# Abilene LE- ADA Evaluation

**LE- Abilene TX, ADA Evaluation**  
**281 N Willis St**  
**Westwood Richland, TX 79603**  
**Accessibility Evaluation**  
**Inspection Date: 05/08/2023**  
**Inspectors: Christopher Meza**

Report Date: 01/12/2024

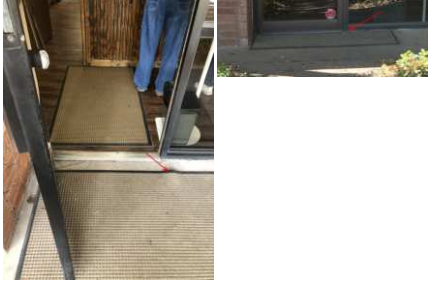
7	Exterior of Property (Public): Parking Lot ( 0 Spaces) - Access Aisle Requirments (Van)	The access aisle is missing at the accessible parking stall. Access aisles serving parking spaces shall adjoin an accessible route. Two parking spaces shall be permitted to share a common access aisle.	N/A		<a href="https://www.access-board.gov/ada/#ada-502_3">https://www.access-board.gov/ada/#ada-502_3</a>	2012 TAS Section: 502.2 2010 ADAS Section: 502.2

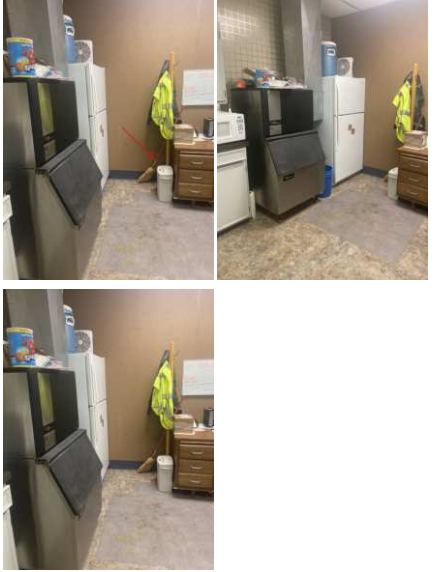
13	First Floor Main Building LOBBY (Public): Entrance into Lobby - Entrance Doors	The door is equipped with a door closer and returns to a closed position too quickly. Door closers and gate closers shall be adjusted so that from an open position of 90 degrees, the time required to move the door to a position of 12 degrees from the latch is 5 seconds minimum.	N/A	<a href="https://www.access-board.gov/ada/#ada-404_2_8_1">https://www.access-board.gov/ada/#ada-404_2_8_1</a>	2012 TAS Section: 404.2.8.1 2010 ADAS Section: 404.2.8.1		
14	First Floor Main Building LOBBY (Public): Entrance into Lobby - Entrance Doors	The door does not open at least 90 degrees. Door openings shall provide a clear width of 32 inches minimum. Clear openings of doorways with swinging doors shall be measured between the face of the door and the stop, with the door open 90 degrees. There shall be no projections into the required clear opening width lower than 34 inches above the finish floor or ground. Projections into the clear opening width between 34 inches and 80 inches above the finish floor or ground shall not exceed 4 inches.	Entrance door does not open 90 degrees	<a href="https://www.access-board.gov/ada/#ada-404_2_3">https://www.access-board.gov/ada/#ada-404_2_3</a>	2012 TAS Section: 404.2.3 2010 ADAS Section: 404.2.3

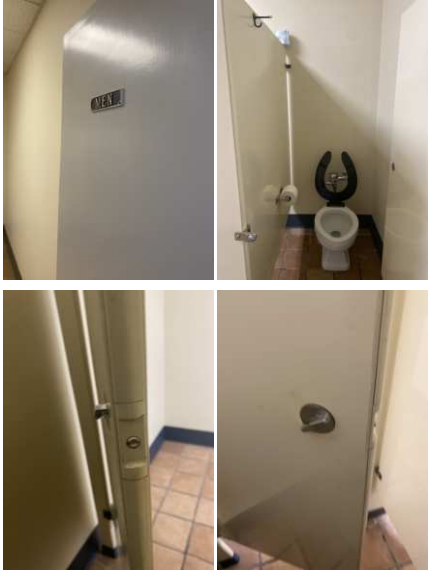
16	First Floor Main Building LOBBY (Public): Lobby Area - Service Counter	Accessible counters are not provided for all the different types of sales and service counters available. At least one of each type of sales counter and service counter shall be accessible.	There are no accessible service desk at this location. Service desk does not provide knee or toe space for front approach and does not meet requirements for parallel approach.	<a href="https://www.access-board.gov/ada/#ada-227_3">https://www.access-board.gov/ada/#ada-227_3</a>	2012 TAS Section: 227.3  2010 ADAS Section: 227.3

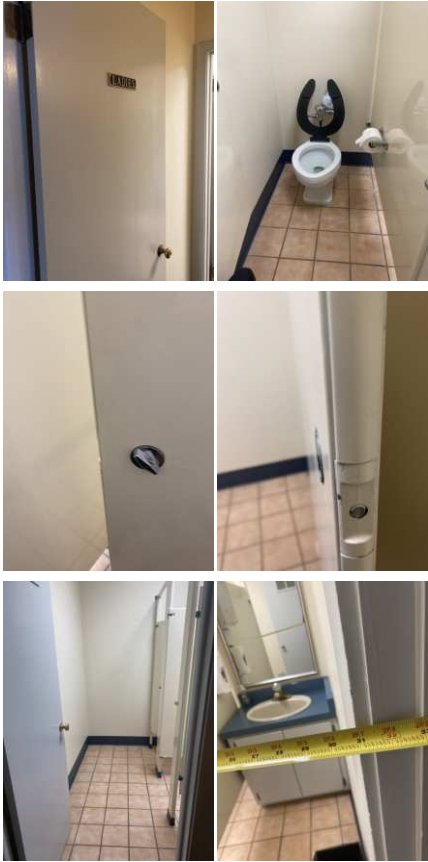
20	First Floor Main Building (STAFF): Kitchenette	The top of the sink is above the allowable height requirement. Sinks shall be installed with the front of the higher of the rim or counter surface 34 inches maximum above the finish floor or ground.	Sink height and counter over 34" Sinks are not accessible via frontal or parallel approach due to rim height. Sinks do not require knee and toe space since there is no stove top oven in vicinity,	<a href="https://www.access-board.gov/ada/#ada-606_3">https://www.access-board.gov/ada/#ada-606_3</a>	2012 TAS Section: 606.3  2010 ADAS Section: 606.3
